TRANS/WP.29/759
20 December 2000

World Forum for Harmonization of Vehicle Regulations (WP.29)

DRAFT 01 SERIES OF AMENDMENTS TO REGULATION No. 96

(Emissions of agricultural and forestry tractors)

Model A

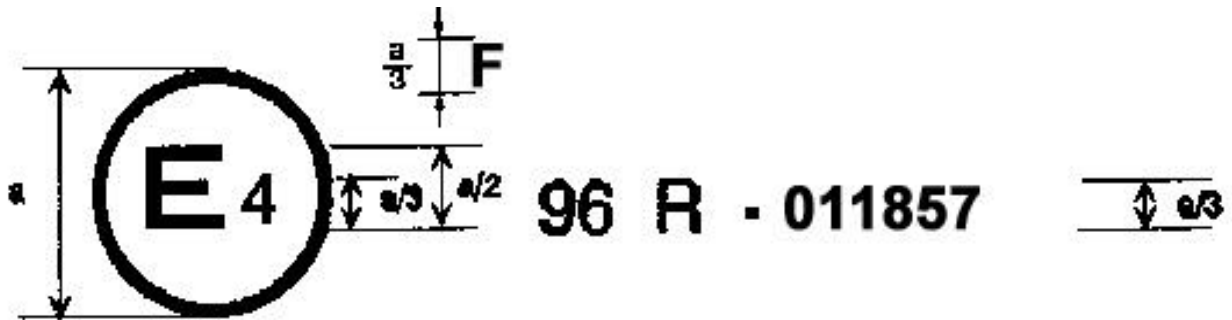
Annex 3, amend to read:

The above approval mark affixed to an engine shows that the engine type concerned has been approved in the Netherlands (E4) pursuant to Regulation No. 96 (according to the level corresponding to power band F) and under approval number 011857. The first two digits of the approval number indicate that Regulation No. 96 was in its amended form (01 series of amendments) when the approval was granted.

Model B

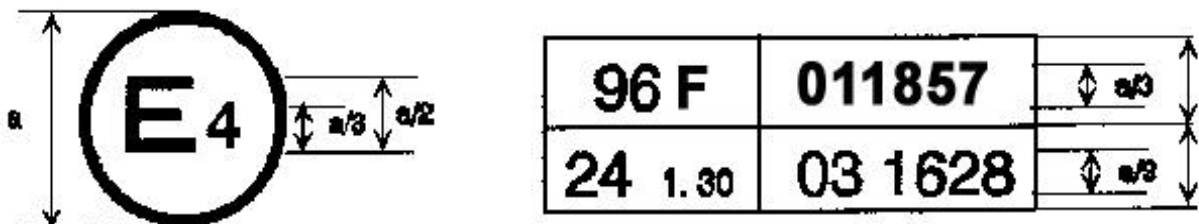
The above approval mark affixed to an engine shows that the engine type concerned has been approved in the Netherlands (E4) pursuant to Regulations Nos. 96 (according to the level corresponding to power band F) and 24. The first two digits of the approval number indicate that, at the dates when the respective approvals were granted, Regulation No. 96 was already in its amended form (01 series of amendments) and Regulation No. 24 already included the 03 series of amendments."
